EXHAUST RETARDER SYSTEM

The new model has the following modifications in the exhaust retarder system:

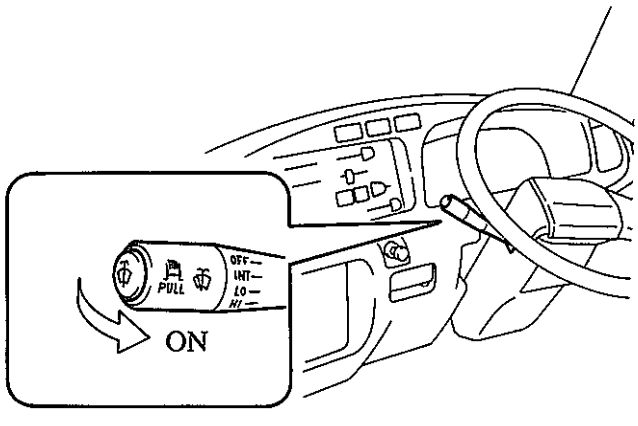
- Main switch relocated.
- Main switch discontinued on 14B engine models for Hong Kong.
- Asbestos-free exhaust retarder gaskets used.

New (RHD Model)

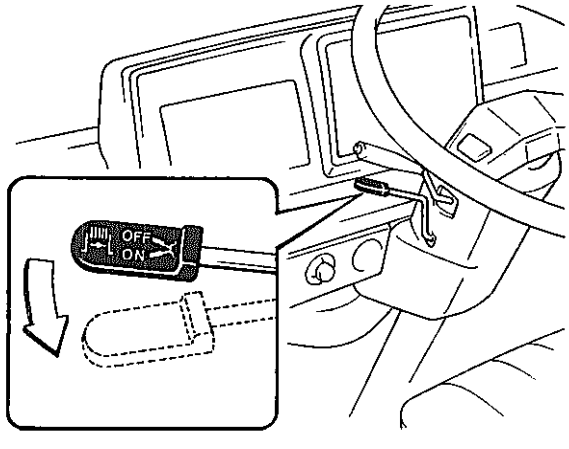
Main Switch

The previous model used a dedicated main switch. However, the main switch of the new Coaster is integrated with the wiper and washer switch, and discontinued on 14B engine models for Hong Kong.
